AMBASSADOR CONSTRUCTION CO., INC.

RE: Mayor's Office of Emergency Management
7 World Trade Center - 1, 7 & 23rd Floors
Change Order #077
Amb. Job # S57-5175

MAYORS OFFICE OF EMERGENCY MANAGEMENT

PENTHOUSE ELEVATION & EXTERIOR DETAIL

FSK-52

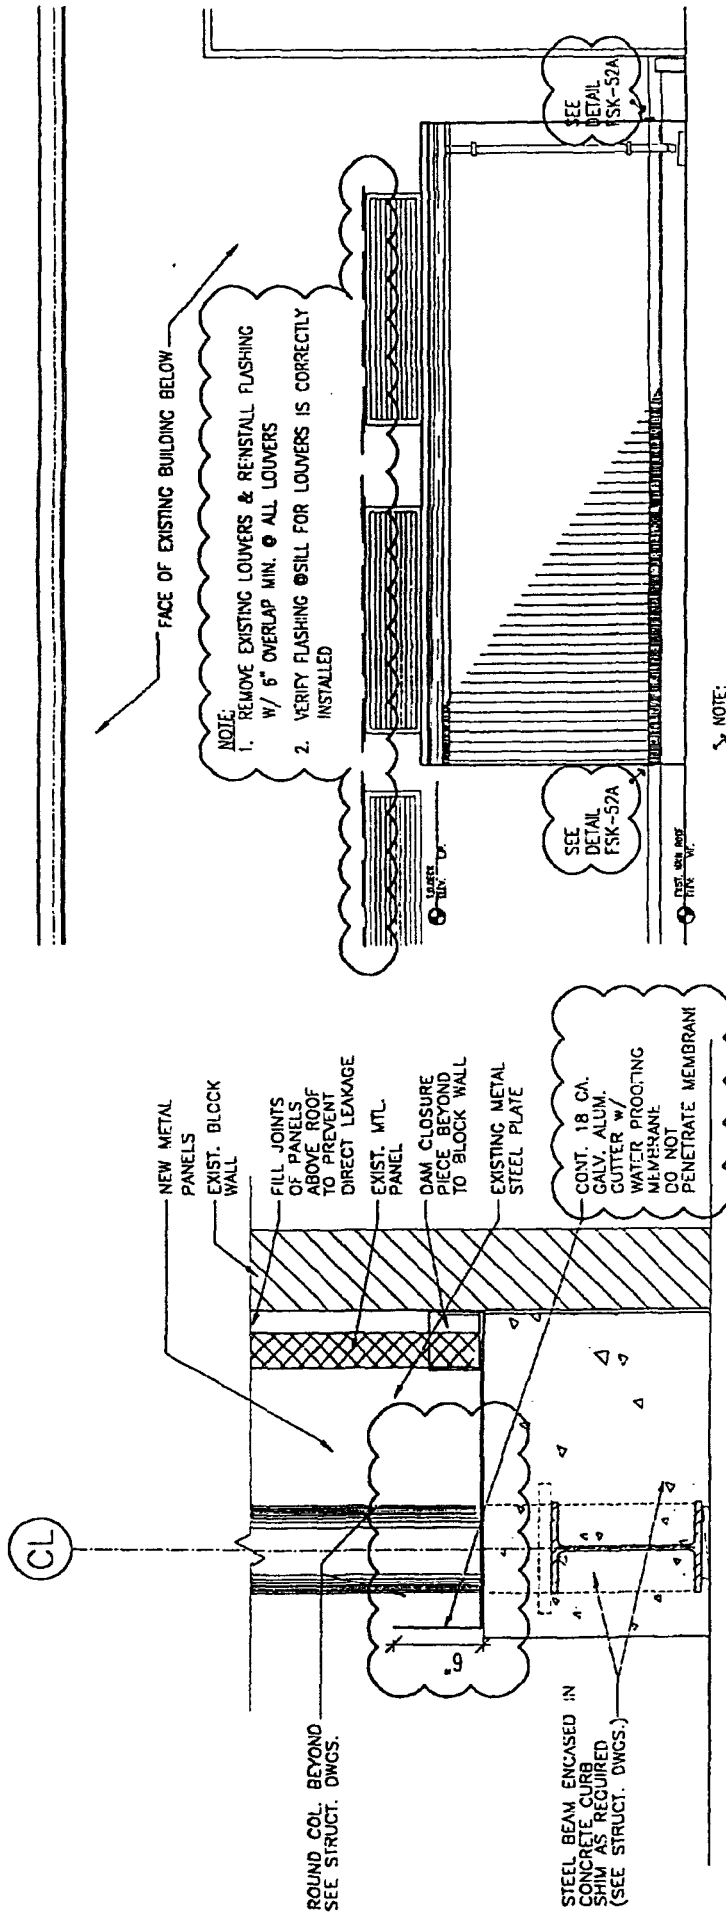
- Furnish and install two (2) aluminum dam closures where new panel walls abut existing wall system.
- Remove existing louver and install continuous flashing and re-install louvers.
- Furnish and install all aluminum drip pan @ back concrete curb.

Additional flashing details as per Swanke Hayden Connell's office sketches 52 and 52A dated 1/29/99 attached.
